## Index 695-001 Traffic Monitoring Site

### COMMENTARY

The foundations within Indexes 646-001, 654-001, 695-001, and 700-120 are being updated to be more consistent between applications. A structural analysis was completed to determine if the foundations could be revised to provide a more consistent design between the various applications. The aluminum posts callouts will be changed to be consistent with other Indexes.

**LANE CONFIGURATION FOR TMS INDUCTIVE LOOP AND STRAIN GAUGE/QUARTZ AXLE SENSOR**

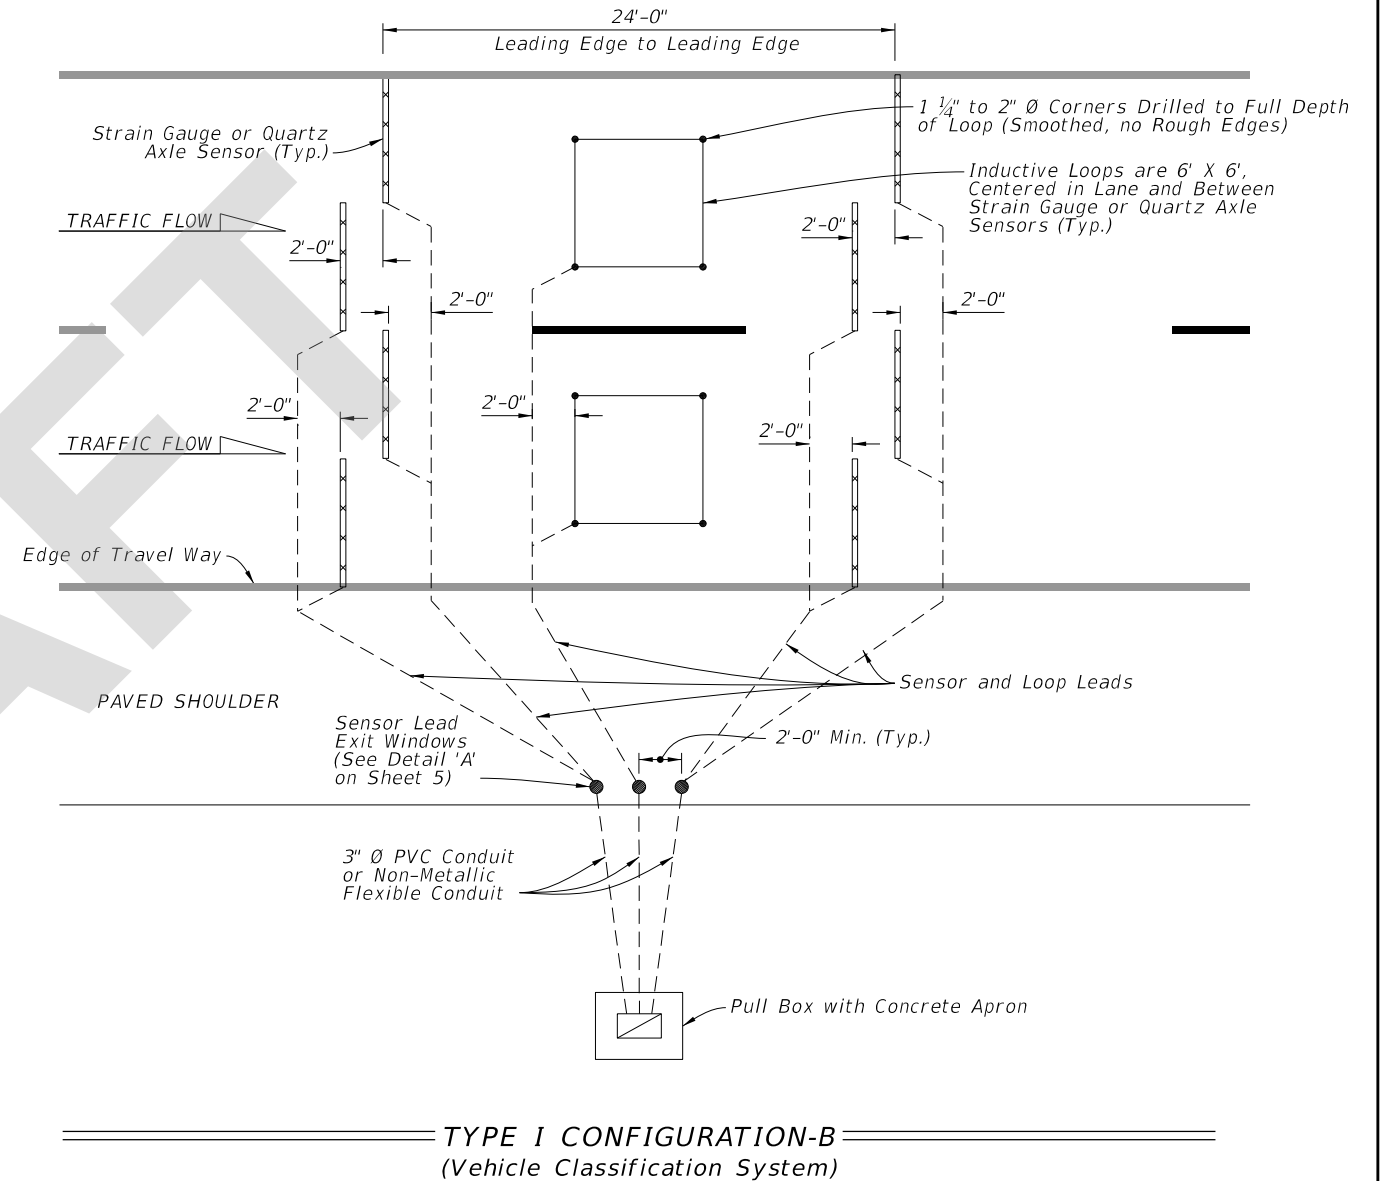
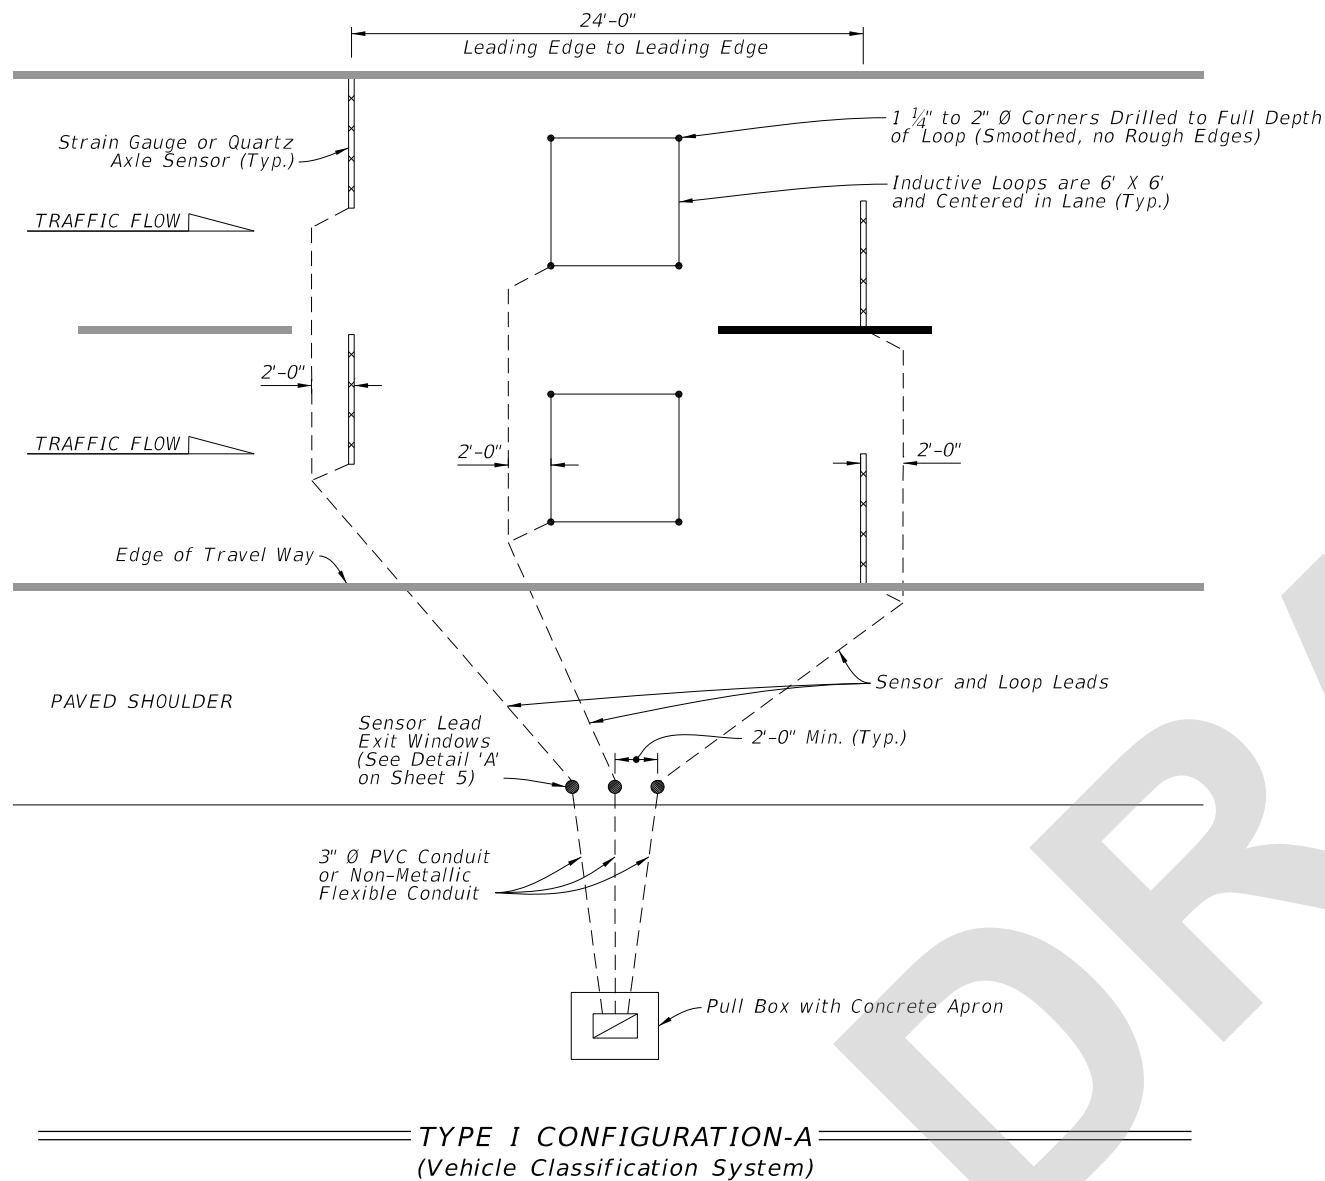
**COMMENT:** The note on Sheet 7 should be placed on Sheet 6, which illustrates the telemetered traffic monitoring sites (TTMS). Since class I type piezo sensors was removed from weight sensor section then the note should read: the TTMS lane layout should be quartz-quartz-loop-quartz-quartz or strain gauge-strain gauge-loop-strain gauge-strain gauge to capture the wheel weights.

**RESPONSE:** Agree. The Index will be updated to show the two new TTMS lane layouts as Configuration-A and Configuration-B. The new layouts will provide weights for the left wheel base and the right wheel base. Each configuration is specific to the vehicle classification unit make and model. The type of sensor used in either configuration can either be strain gauge or quartz.

**Change Made:** The Index will be updated with the new sensor layouts.

LANE CONFIGURATION FOR MAINLINE INDUCTIVE LOOP AND QUARTZ AXLE SENSOR

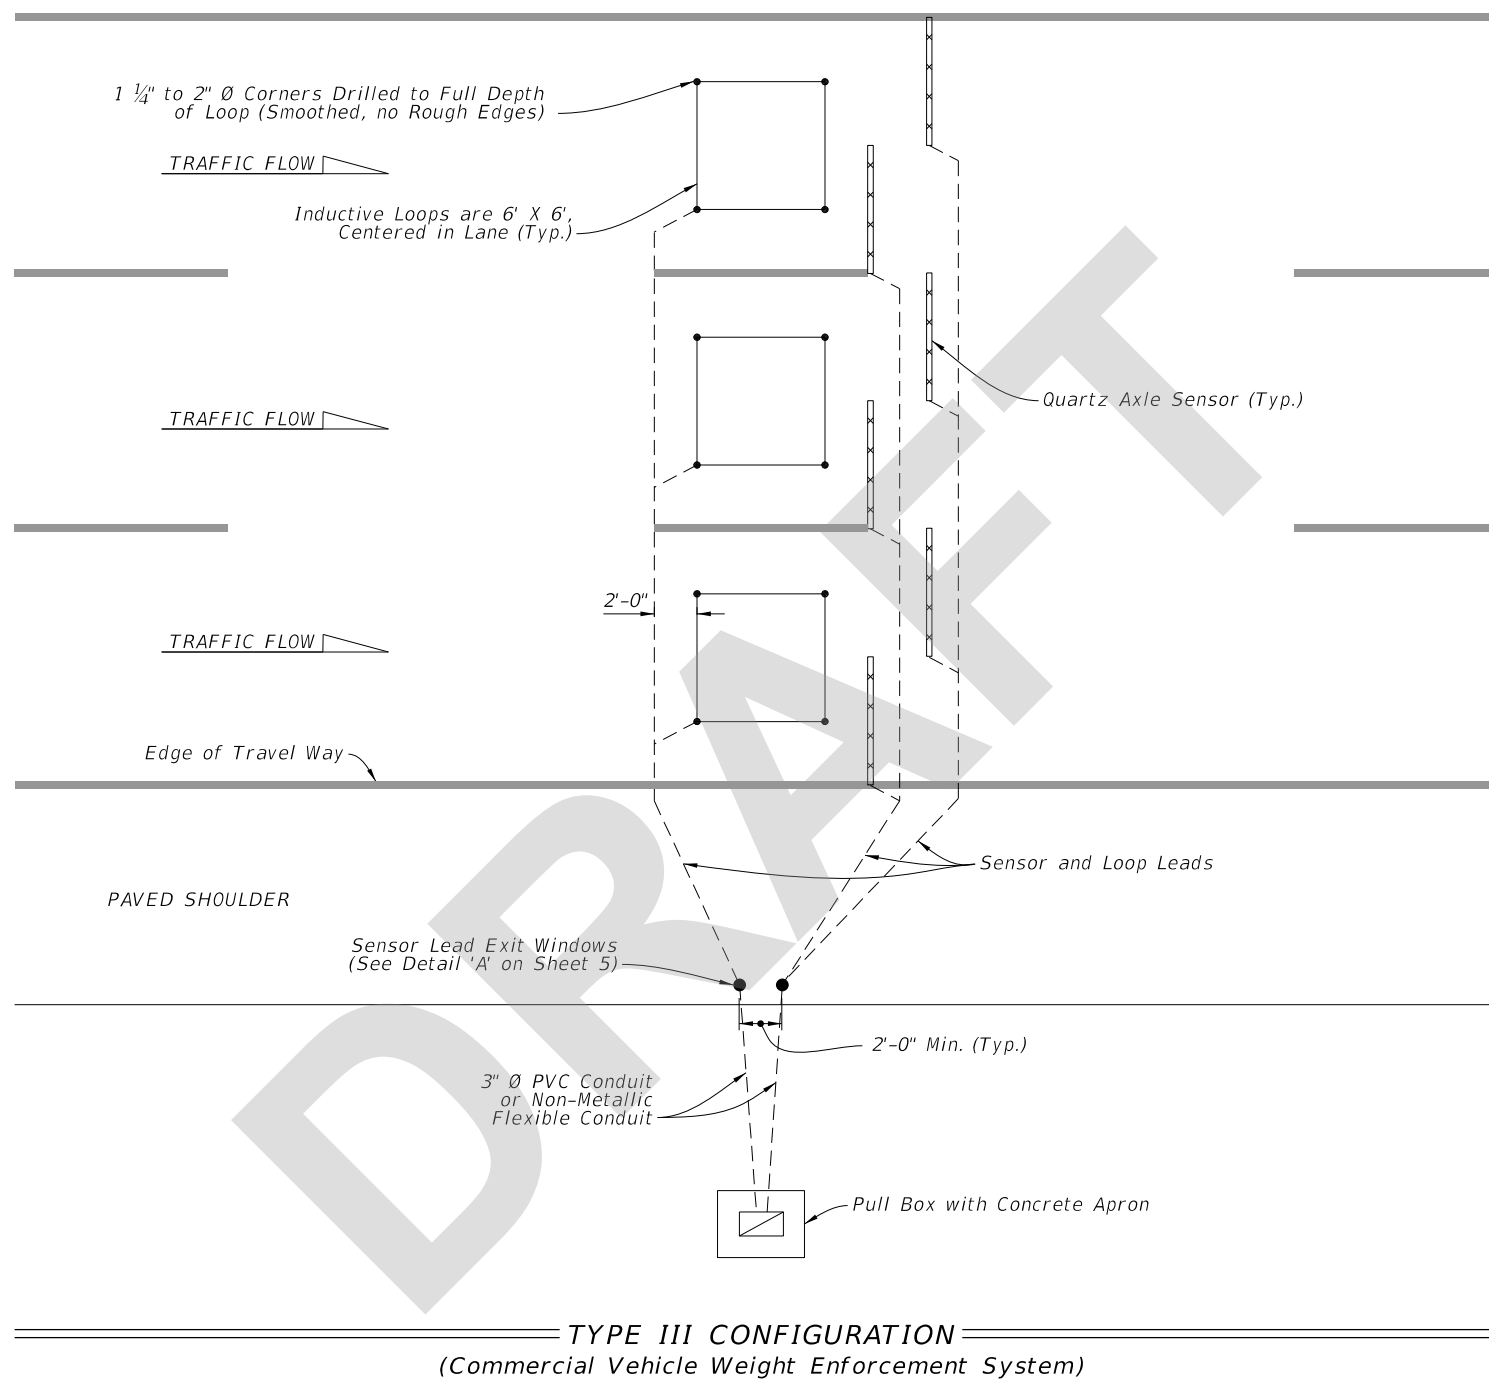
**COMMENT:** Comment: Sheet 7 should reflect an enforcement system. The FDOT Motor Carrier Size and Weight is currently installing a mainline virtual weigh-in-motion screening station at the White Springs facility. The lane layout should be loop-quartz-quartz.

**RESPONSE:** Agree. The mainline virtual weigh-in-motion (VWIM) screening station will provide more efficient enforcement operations by allowing compliant commercial vehicles to continue travels on the freeway. The VWIM layout provide weights for the left wheel base and the right wheel base. Non-compliant commercial vehicles will be notified to exit into the weigh station. The enforcement system uses the quartz sensor.

**Change Made:** The Index will be updated with the new sensor layout.

SOLAR POWER POLE WITH POLE MOUNTED CABINET (Telemeter Sites)

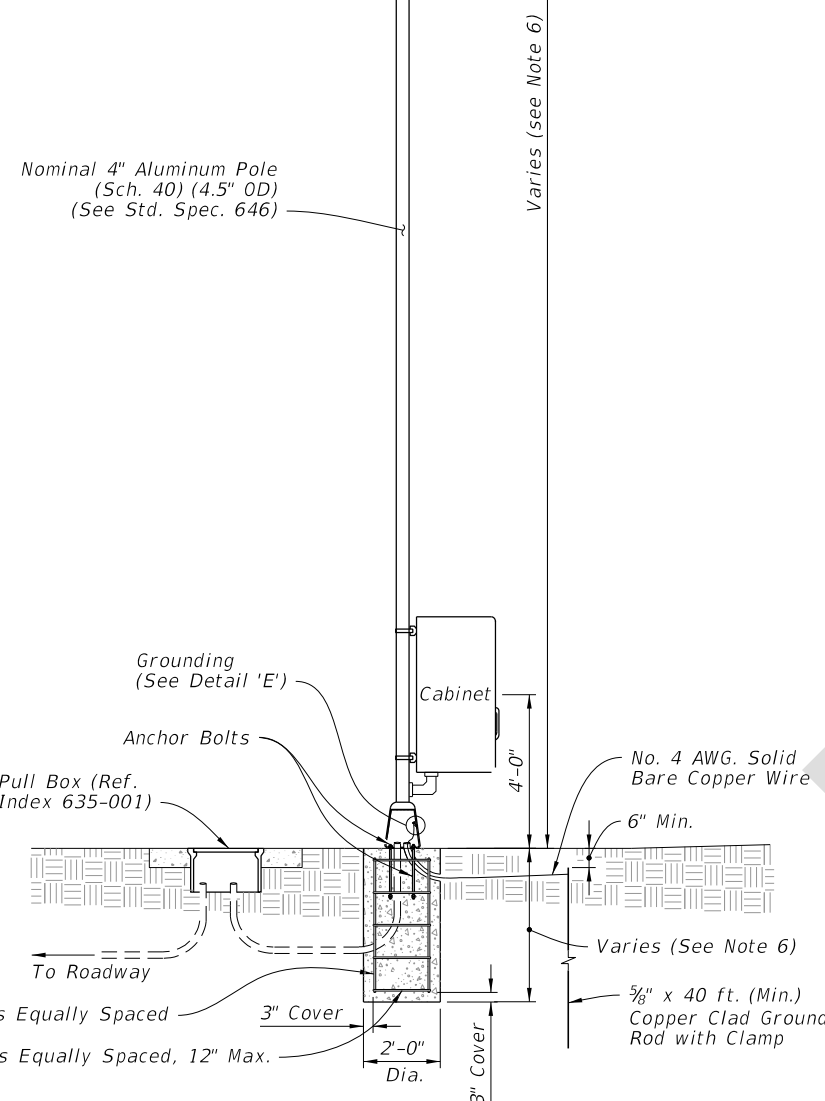
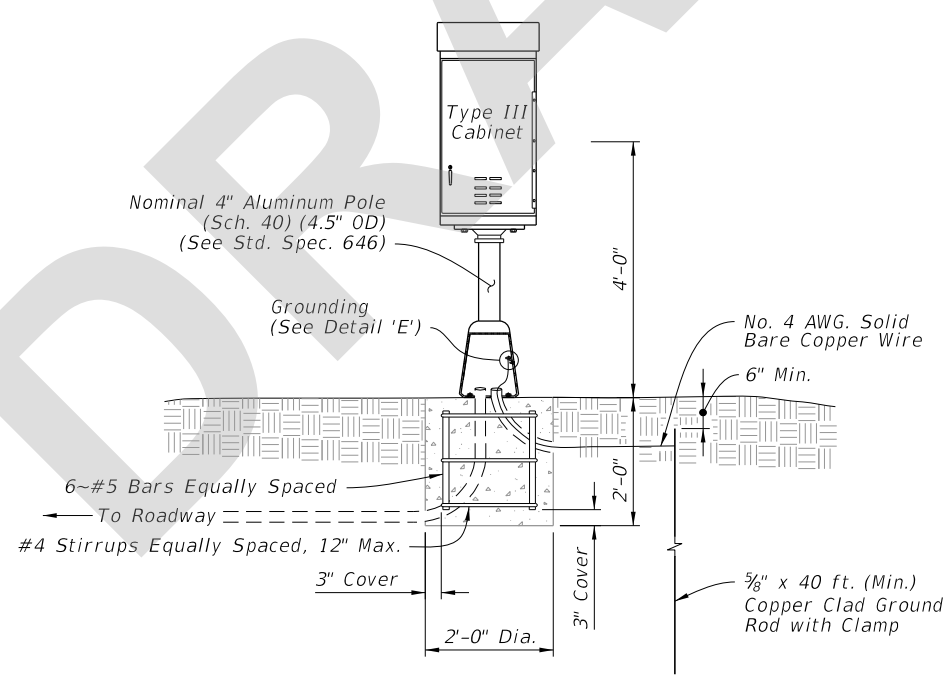
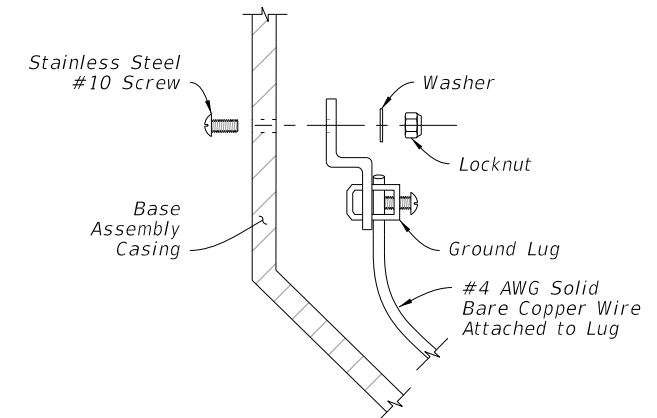
**COMMENT:** Has the revision of pole diameter callouts from 4" nominal to 4.5" OD been properly coordinated? This change could incur cost updates and other design considerations and affect APL. Were structural parameters considered? Specification 646 references 4" nominal which needs to be updated.

**RESPONSE:** The pole/posts are not changing with this update so there are no issues with the APL or additional costs incurred. This change was requested by the Structures Office to make callouts consistent with other Indexes that specify pole/post dimensions. The 4" nominal and 4.5" OD are the same callout in this scenario based on ASTM B429 which is a requirement of Spec 646. Although there is no conflict, Spec 646 will be updated to be consistent with the new callout in Indexes 646-001, 654-001, 695-001, and 700-120. The callout in the indexes will be updated to clarify that the poles/posts are not changing.

**Change Made:** **Revise callouts in the Indexes and Spec to read "Nominal 4" Aluminum Pole (Sch. 40) (4.5" OD)"**
